PLANNED UNIT DEVELOPMENT **REZONING &** SIDEWALK WAIVER REQUEST

STAFF REPORT Date: January 16, 2014

APPLICANT NAME **Gulf Equipment Corporation**

LOCATION 5540 Business Parkway

SITE PLAN

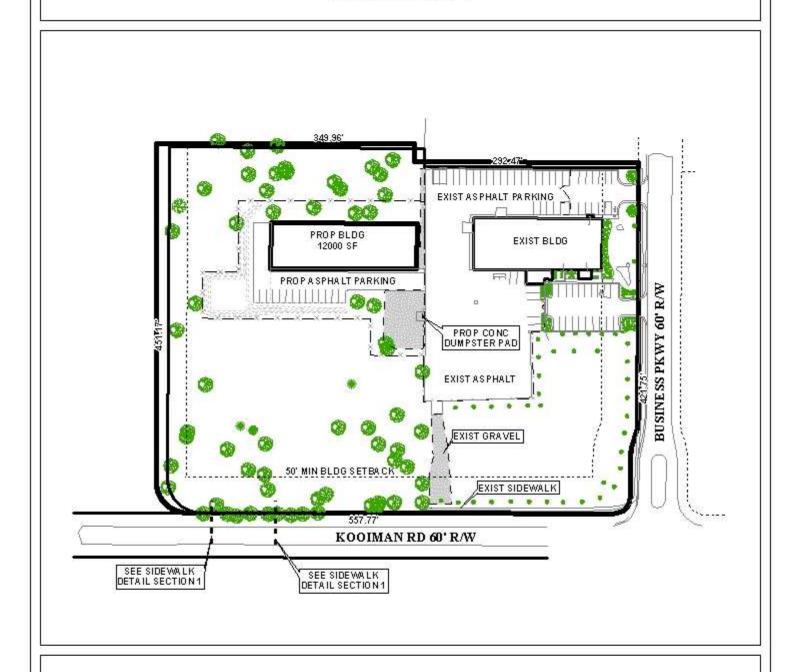
It should be noted that there appears to be a discrepancy on the site plan in reference to the number of parking spaces. The site plan only illustrates the existing and proposed buildings along with the square footage of each, but does not, however, illustrate a location or size of an office nor provide the number of warehouse employees as the Zoning Ordinance requires 1 space for every 3 warehouse employees. Currently, the site contains an existing 12,368 square foot building with 62 parking spaces, as counted by staff, and is required 42 spaces, as stated on the site plan. The applicant is proposing the construction of an additional 12,000 square foot building which is required 40 parking spaces, as stated on the site plan; however, the applicant only provides 14 additional parking spaces. As parking will be shared between the two buildings, the applicant states that a total of 82 parking spaces are required. A note on the site plan states that there are 68 existing parking spaces and with the additional 14 proposed parking spaces, the site will have a total of 82 spaces, as required. Since staff has counted only 62 parking spaces on the site plan, the 14 proposed parking spaces would only provide 76 on-site parking spaces, 6 short of the required 82.

It should be pointed out, that it appears the applicant has calculated parking on the site using the General Business parking ratio which is 1 space per 300 square feet for the entire area of each

structure, instead of using the Office-distribution mixed use establishment parking ratio where the location and size of an office would be provided and parking calculated at 1 space for every 300 square feet and the remaining area would calculate parking at 1 space for every 3 warehouse employees. Using the Office-distribution parking ratio would possibly generate a lower parking requirement for each structure and the entire site, and, as such, it is recommended that the site plan be revised to comply with the Office-distribution parking ratio; however, if the applicant desires to continue the 1 to 300 parking ratio, the site plan should be revised to depict a total of 82 parking spaces.

It should be pointed out that the site plan illustrates a metal cover that covers two existing parking spaces along the Northern lot line near the existing building. The exact size of the structure and support columns is not identified, and, as such, may reduce the provided parking on the site.

A note on the site plan references the total landscaping area required and the existing landscaping area, but does not reference the frontage tree requirement as required by the Zoning Ordinance. As a result, the site plan should be revised to comply with the frontage tree requirement of the Zoning Ordinance.

It should be pointed out that a detailed container plan was provided by the applicant and the site plan depicts a dumpster pad as well; however, the applicant does not illustrate the dumpster pad connected to sanitary sewer. The site plan should be revised to comply with Section 64-4.D.9. of the Zoning Ordinance.

1) Revision of the site plan to illustrate 82 parking spaces or the compliant number of parking spaces to include the location and size of each office and the number of warehouse employees;

- 2) Revision of the site plan to illustrate and quantify full compliance with the tree and landscaping requirements of the Zoning Ordinance;
- 3) Revision of the site plan depicting the dumpster connected to sanitary sewer as required by Section 64-4.D.9 of the Zoning Ordinance;

- 4) Placement of a note on the site plan stating that: (Any new lighting on the site to comply with the requirements of Sections 64-4.A.2. and 64-6.A.3.c. of the Zoning Ordinance.);
